Engineering Change Notice

Part No. <u>2898</u>	ECN No. <u>23-004</u>
Part Name <u>2032 COIN CELL RETAINER</u>	Date <u>1.11.23</u>
Rev. <u>B</u>	ECR No. <u>—</u>

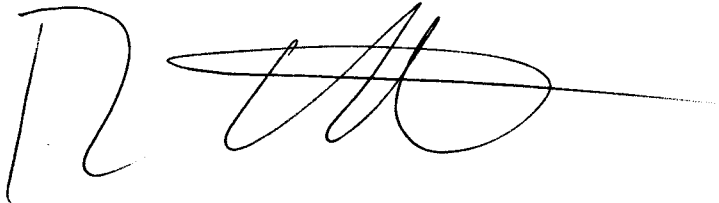
POLARITY STAMP HAS BEEN UPDATED. INSTEAD OF CUT THRU MATERIAL STAMP IS EMBOSSSED NOW

Solution: Tooling Change Required

REVISE C+M DWG
